Addendum 1 to Cavalon Gyroplane Maintenance Manual

**For the Rotorhead III modification (MC-382)
and the Garmin G3X installation (MC-389)**

Document number RSUK0412

RotorSport UK Ltd

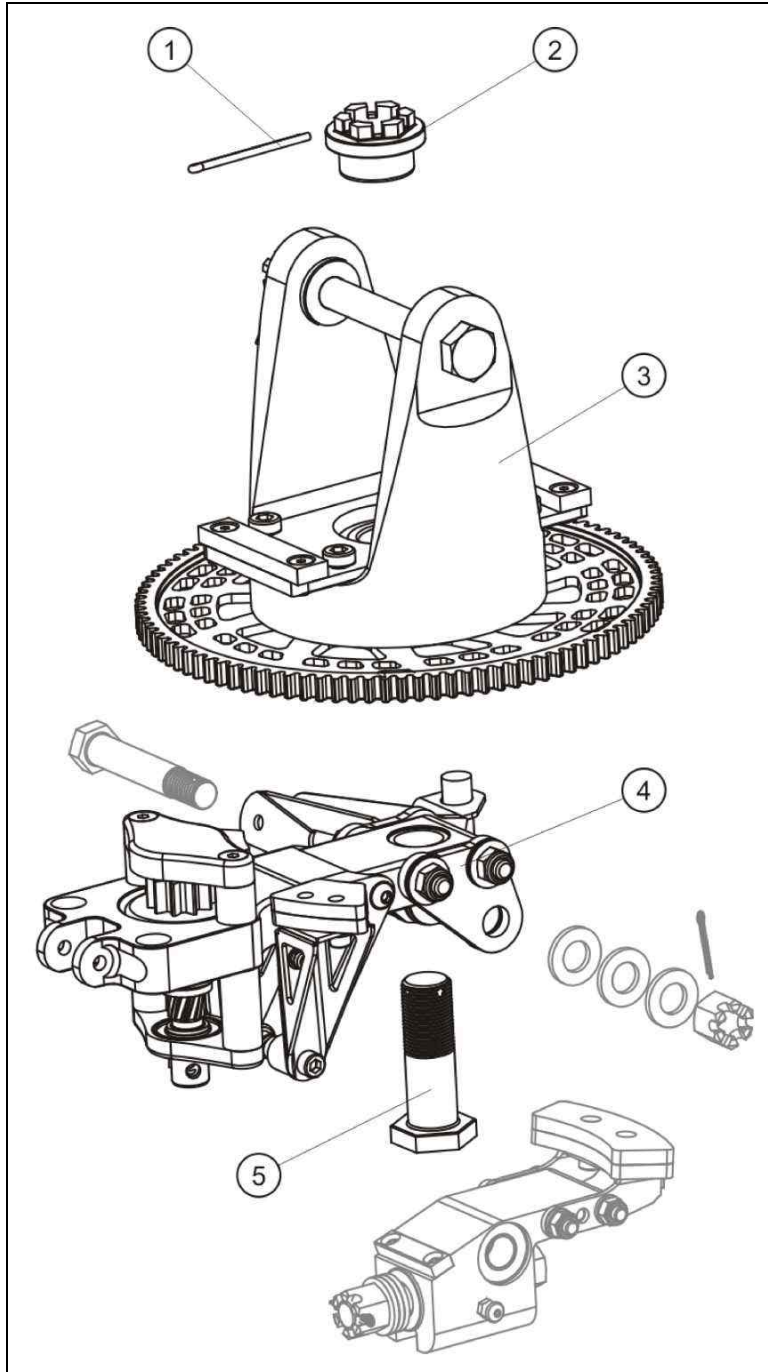
It should be noted that although Rotorhead III accommodates the standard Rotorsystem II rotor variants its teeter tower is different to previous designs so only complete Rotorhead systems should be fitted. The correct teeter tower and teeter block combination **MUST** be used! Short tower plus short block, tall tower plus tall block.

Because the rotorhead is more compact than the original version, a longer mast is also used.

The pre rotator gearbox is also changed to version III. This version includes an improved bearing arrangement and clutch plate material to withstand the increased loadings at 320 rotor rpm.

Exploded view of Rotorhead III

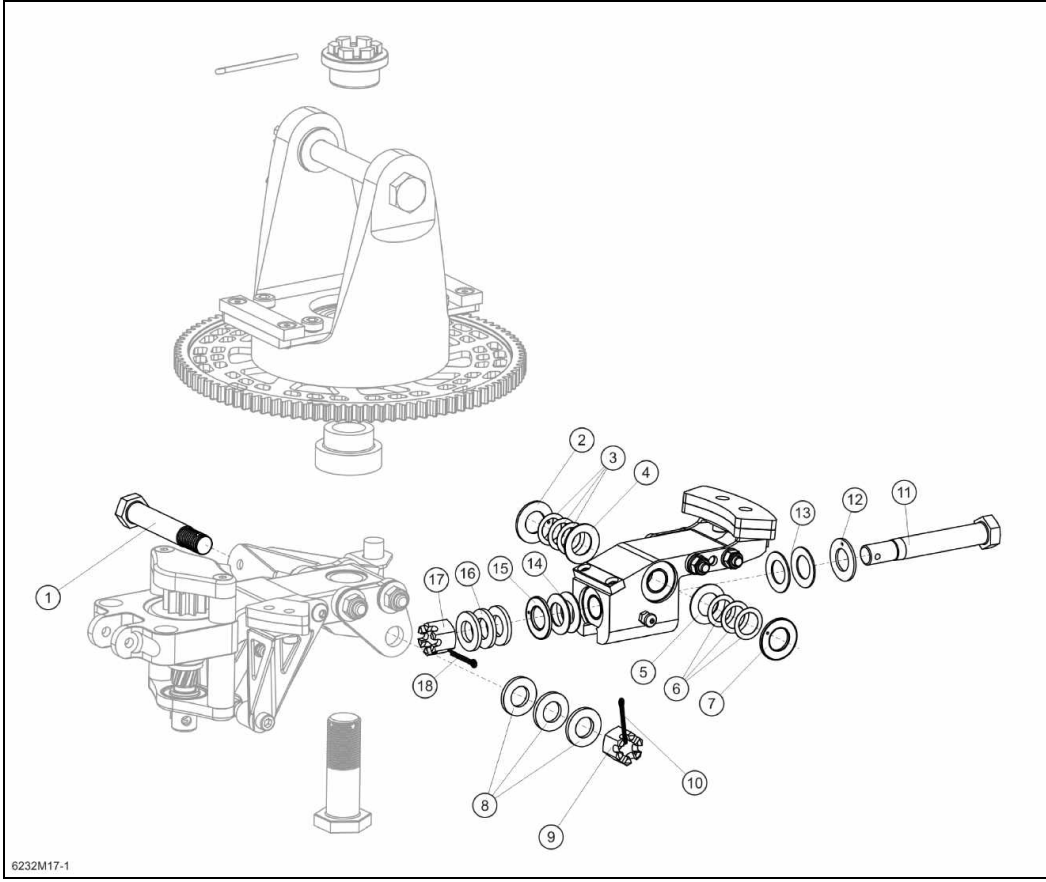
- 1 Inspect rotor head bridge (4) function and condition, i.e. no misalignment, dents, nicks, corrosion, or cracks. In case of any of the aforementioned is evident or suspected contact RSUK customer support.

- 2 Inspect, whether the upper bearing holder for the Bendix shaft is properly secured to the bridge, rectify as required..
- 3 Inspect teeter stops for correct attachment and condition.

- 4 Inspect teeter tower (3) for correct attachment and condition, i.e. no cracks. In case of cracks or unusual condition or appearance contact RSUK customer support.

- 5 Perform torque-check on main bolt nut (2). In order to do so, remove and discard split pin (1) and torque-check castle nut with 120 Nm.
- 6 If torque-check fails, check carefully for any damage of the teeter tower or bearing or system. Only if there is no damage, retorque. If in doubt, contact RotorSport.UK Ltd

- 7 Insert new split pin (1) and secure. Make sure that ends do not contact rotating parts.

Gimbal head assembly showing spring and shim washers

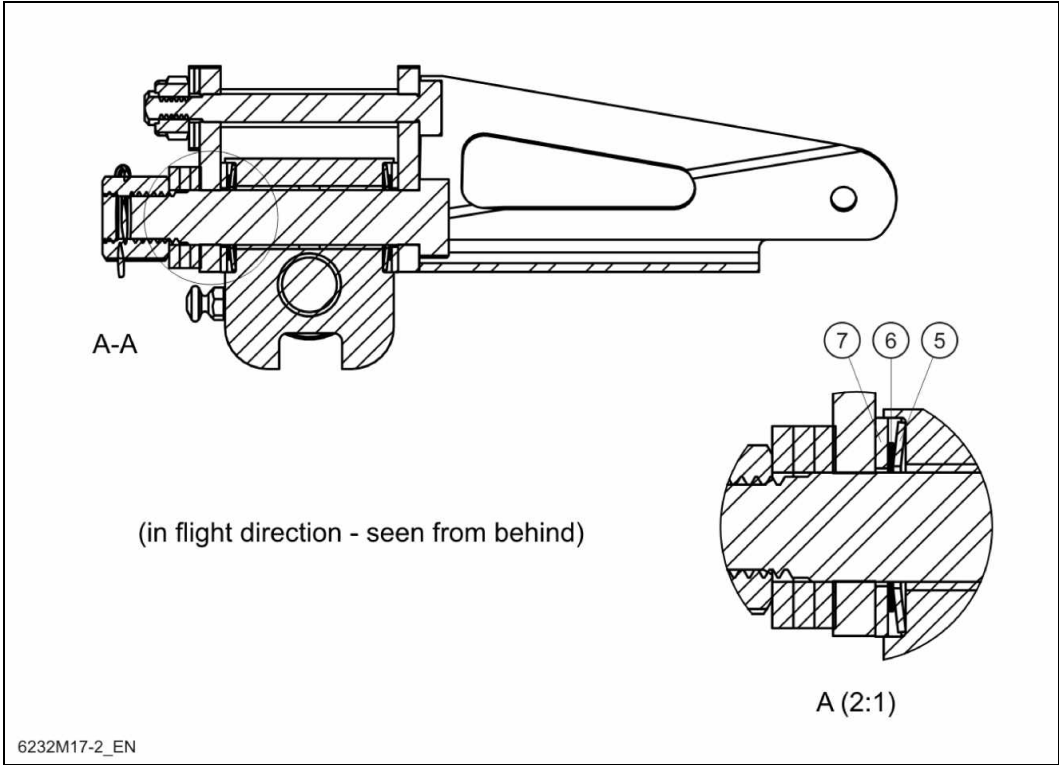
1 Inspect gimbal head for correct function and condition, i.e. check split pins (10) and (18) are installed and no play at the hinge points is evident.

2 Verify angles of gimbal head mechanical end stops. In order to do so perform the following work steps:

3 Place gyroplane on level ground with zero roll attitude and lower mast section vertical.

4 Rotate rotor head so that rotor blades (removed!) would point exactly fore-aft. Place inclinometer on top of teeter tower and measure RH and LH end stop angle. Make sure that mechanical stops are reached. Record values.

5 Rotate rotor head so that rotor blades (removed!) would point exactly left-right. Place inclinometer on top of teeter tower and measure FORE and AFT end stop angle. Make sure that mechanical stops are reached. Record values.

6 Verify measured angles comply with the values specified in the corresponding type certificate data sheet. If any of the values differs by more than 1° from the specified value mark component unserviceable and contact RSUK customer support

Wear Pattern (uneven)

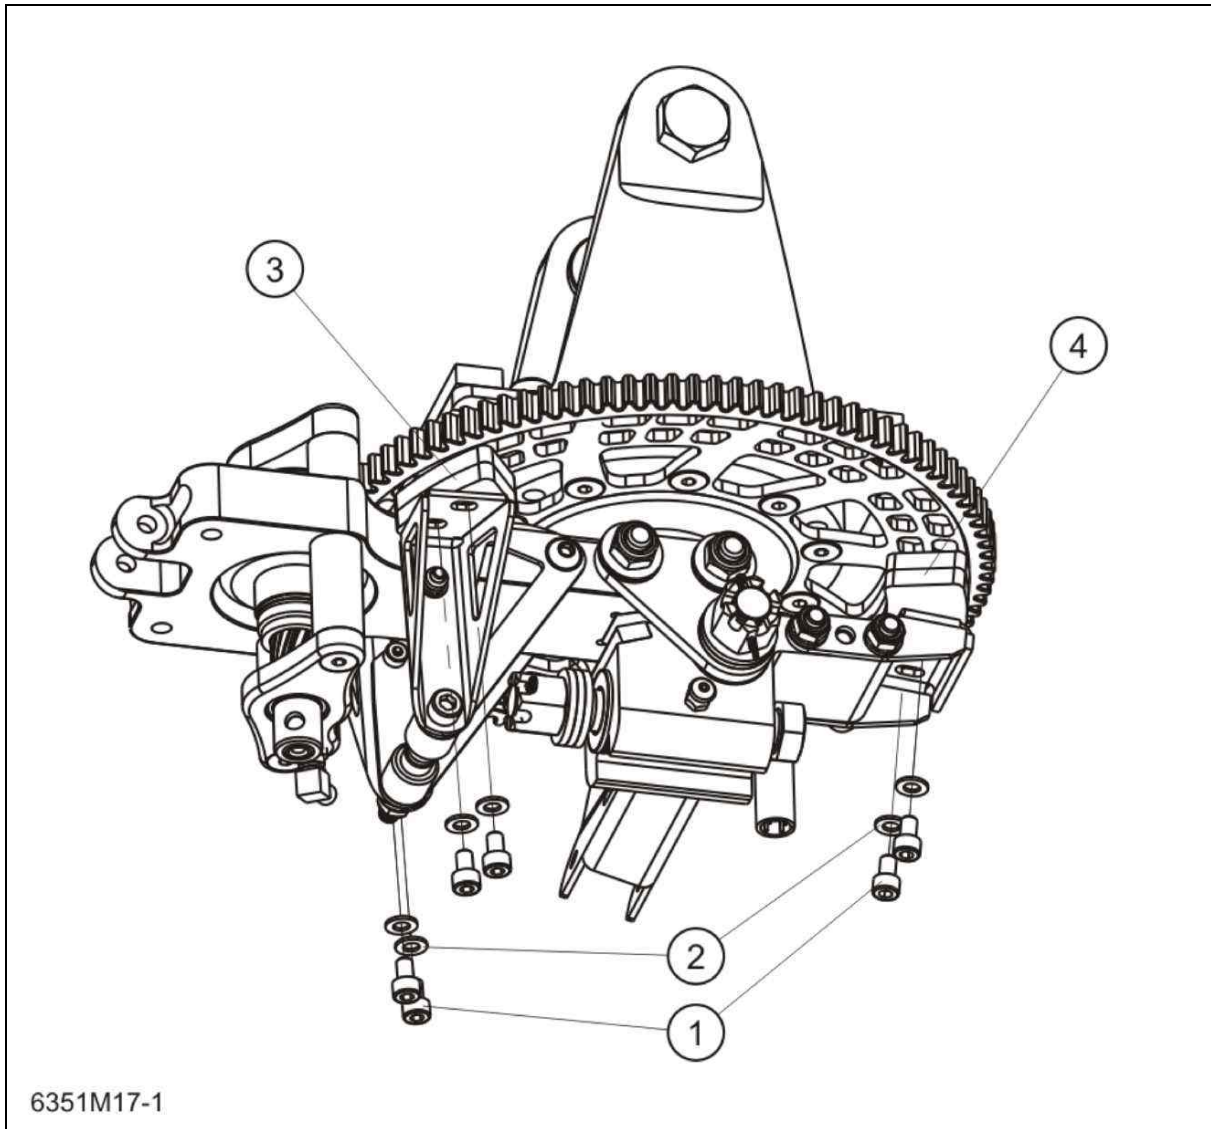
1 Inspect wear pattern and gear mesh of pre-rotator upper engagement. If in doubt, contact RSUK customer support.

2 If the wear pattern is uneven (see photo below), e.g. due to dynamic skew, the pre-rotator upper engagement /Bendix shaft must be repaired according to [63-11-30 8-2](#).

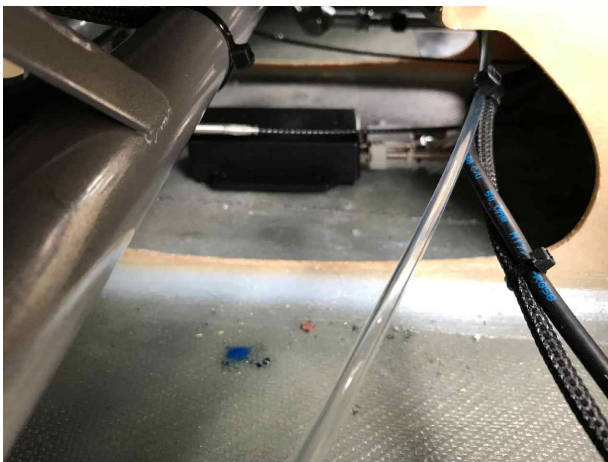
- Airspeed indicator (0-120mph)
- Altimeter (0-20,000ft)
- Magnetic compass (card-compass mounted on the glareshield)
- Slip indicator (in the form of a slip-string attached to the windscreen)
- Rotor rpm gauge (with limitation markings in accordance with T33)
(NB: This is optional and may be incorporated into the Garmin display)
- Radio (ATR833 MkII)

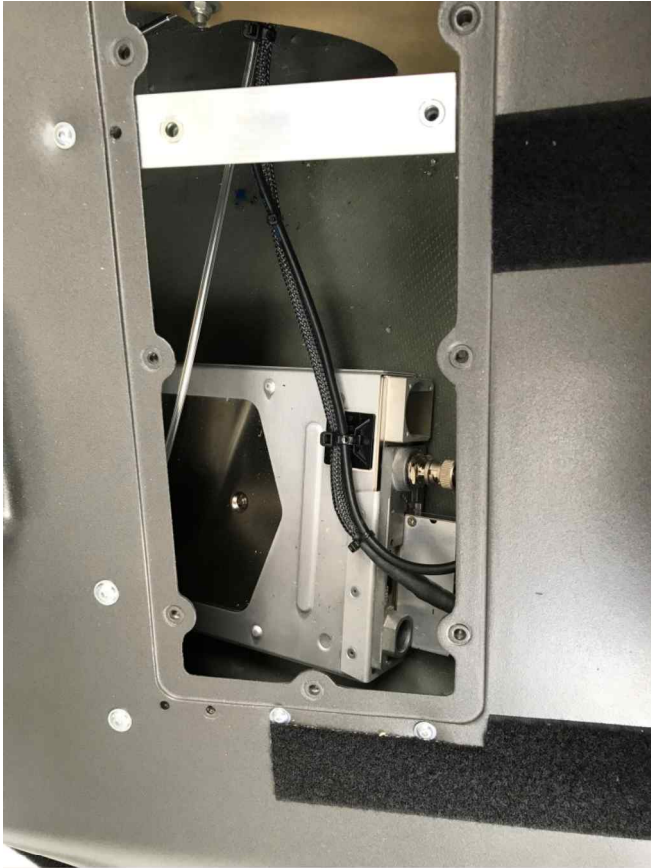
AHRS unit installed in the mid channel, weight ~1.0kg. Bonded to the body floor with structural mastic

Transponder unit located on floor under passenger seat. Weight 1.18kg. Attached by self-adhesive Velcro

EGT sensors mounted into the standard Rotax sensor receptacles

Manifold pressure sensor located in engine bay (attached to engine frame)

Fuel pressure sender integrated into fuel-pipes

Equipment bay mounted Garmin engine information unit. Total weight 0.57kg attached to CFRP bulkhead by M4 cap-screws into threaded inserts
